Re: Sundoro Subdivision Drainage Report

Engineer's Stamp dated 9-17-03, (J9/D18)

DRAINAGE REPORT FOR SUNDORO SUBDIVISION

Re: Sundoro Subdivision Revised Grading Plan

Fred Ambrogi,

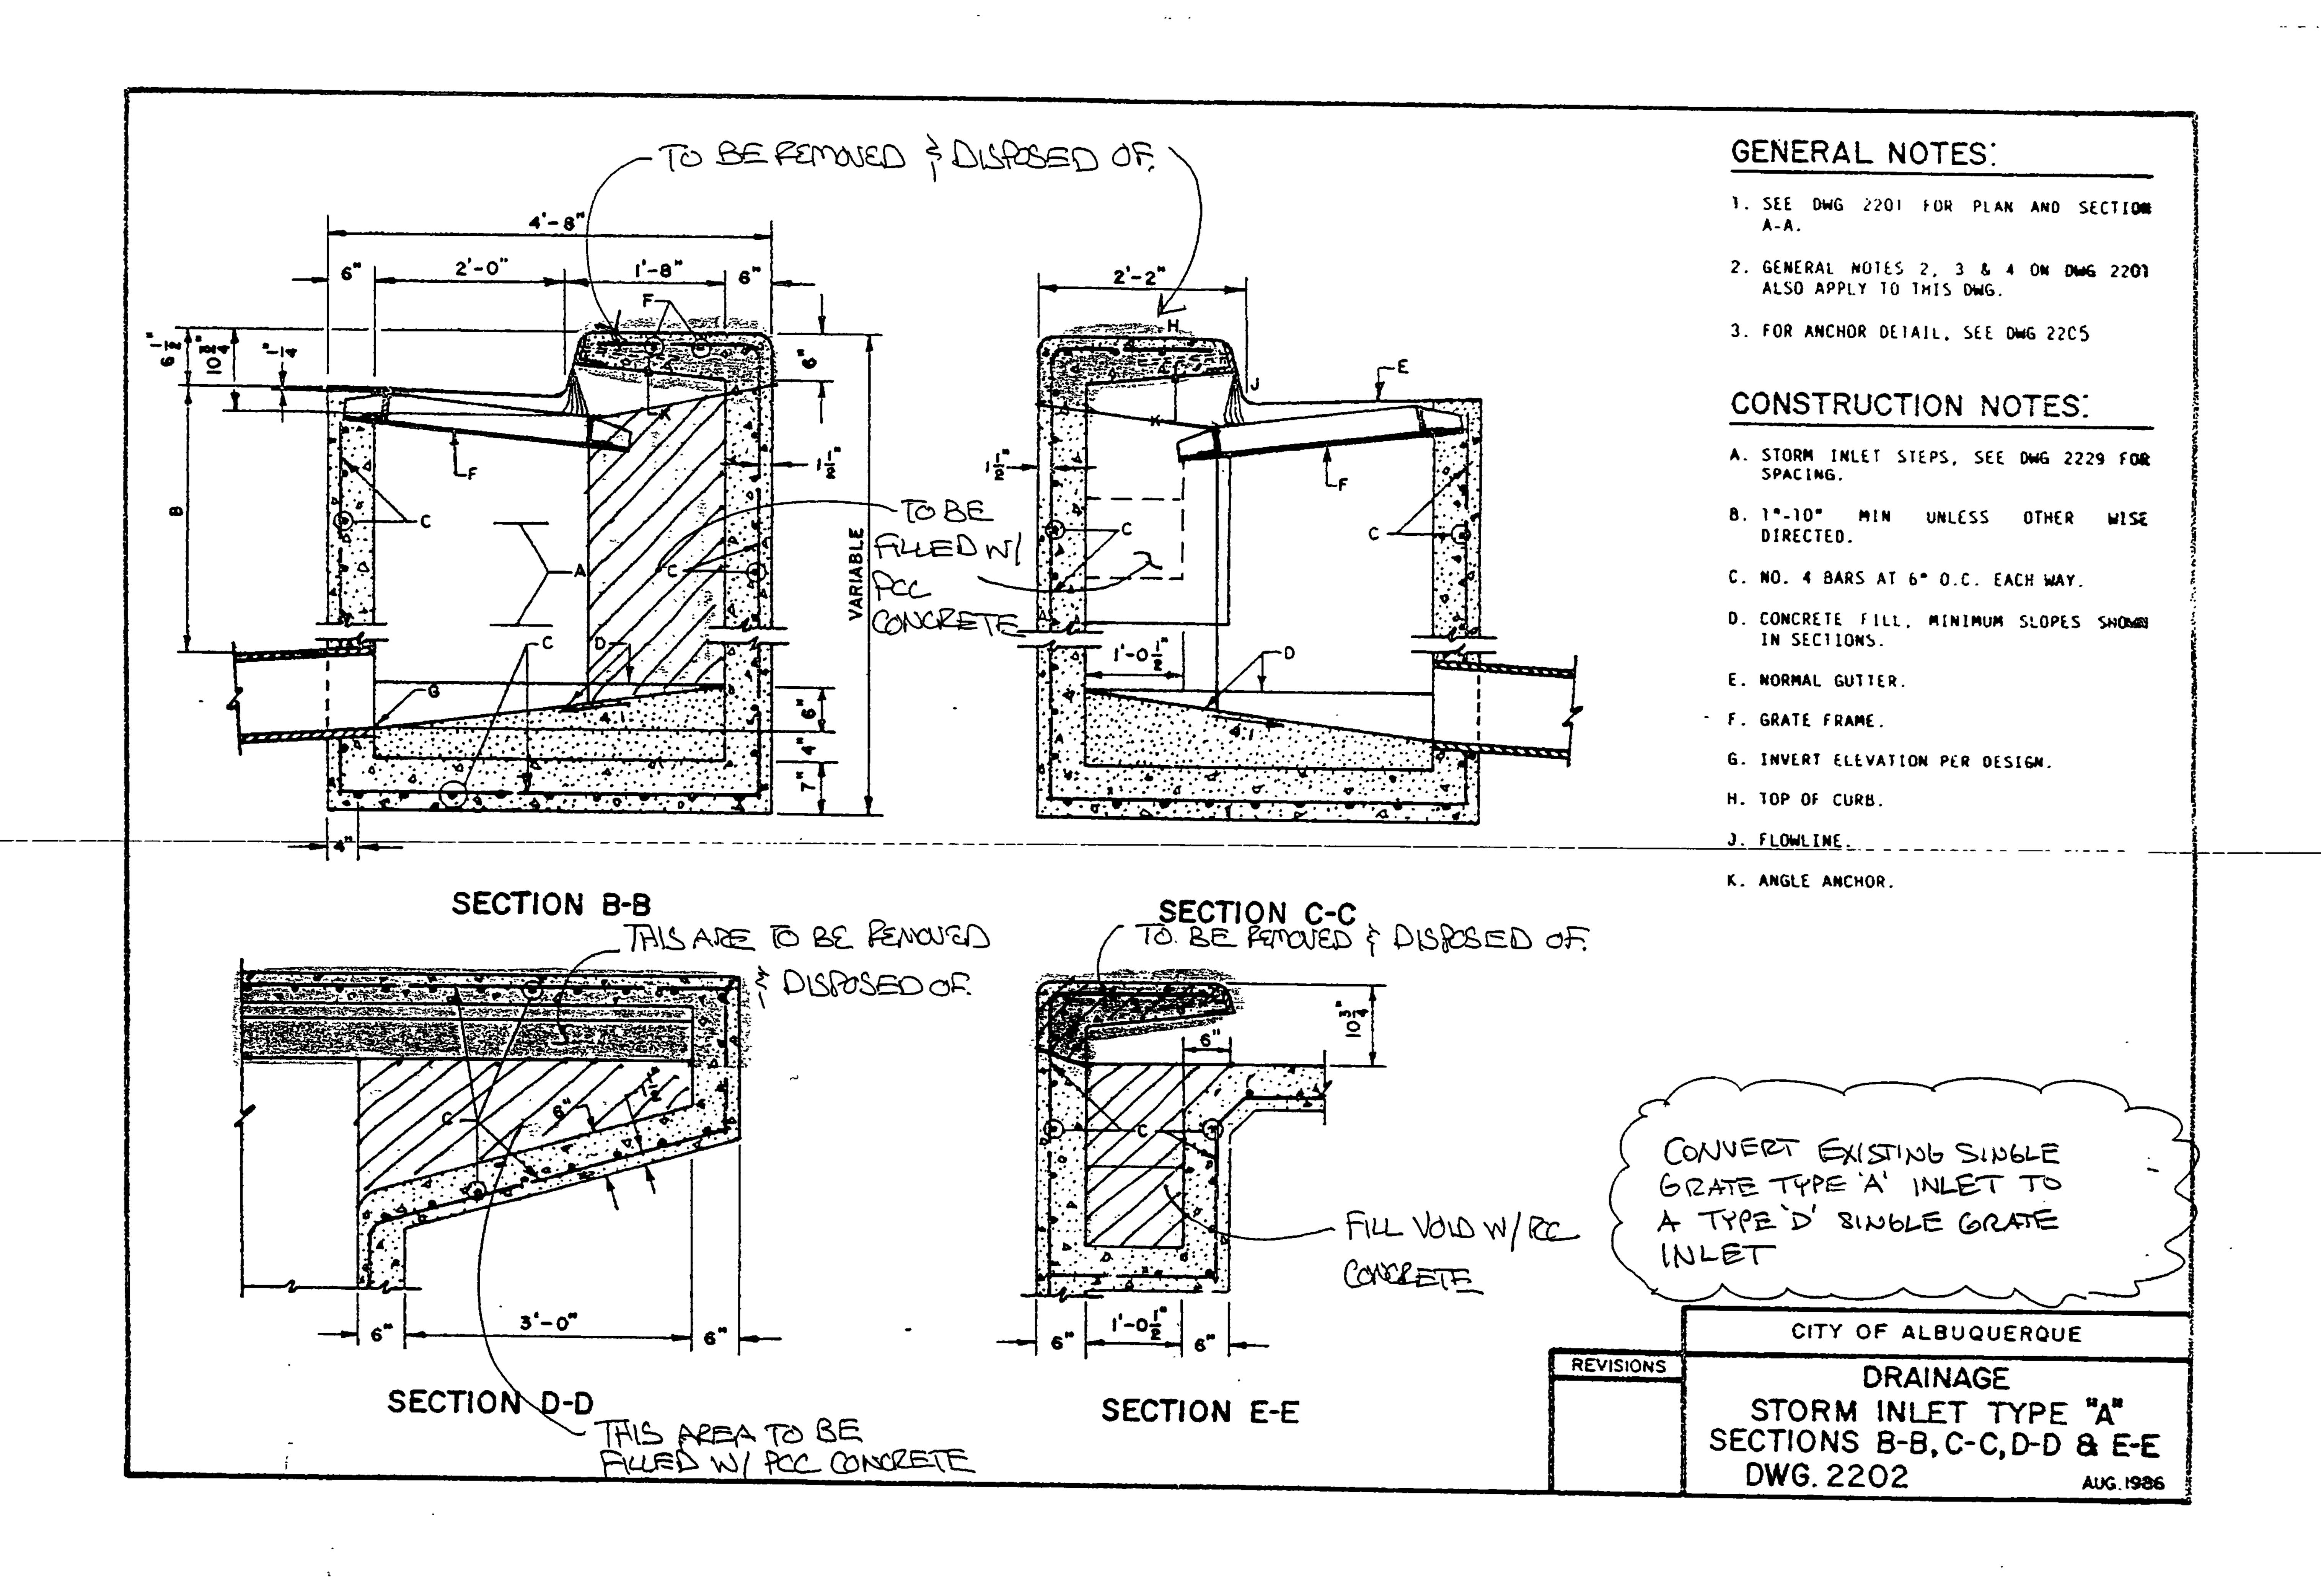
Several weeks ago it was brought to my attention by my perimeter wall contractor, that the northeast corner of the rear yard of the above referenced lot slopes down to the northeast toward an existing AMAFCA easement and a small adjacent parcel owned by Westland. This is a very wide lot at the end of the Makian Place cul-du-sac, which has a large rear and side yard. The entire house pad portion of the lot and the front yard area drain forward to the street and cul-du-sac as specified by the approved grading plan, however the earthwork contractor did not fill the far northeast corner of the lot so it slopes gradually down to the existing natural grade. I no longer had a contractor left on site with heavy equipment to fill the rear corner of this lot, so I advised the wall contractor to turn a block sideways at the low corner so that portion of the yard could drain out to the rear.

Two blocks were turned, one on the north side wall adjacent to the AMAFCA easement and one the east rear wall adjacent to the Westland parcel. Chris Sholtis of BHI looked at the lot and confirmed that the pad area and front yard will drain to the street. He advised me that the maximum flow coming off of the rear corner of lot 39 should not exceed about 0.3 c.f.s., which is significantly less than the historic flows which drained that way prior to the construction of our subdivision. Westland therefore agrees to accept the runoff from the east side turned block on to our parcel. I will have my wall contractor plug the turned block on the north side adjacent to the AMAFCA easement.

Since this portion of the perimeter wall is not designed and constructed as a retaining wall, the expense to make this corner of the lot drain forward to the street would be considerable; much more than is warranted by the minimal magnitude of the drainage situation. Thank you for your consideration regarding this matter.
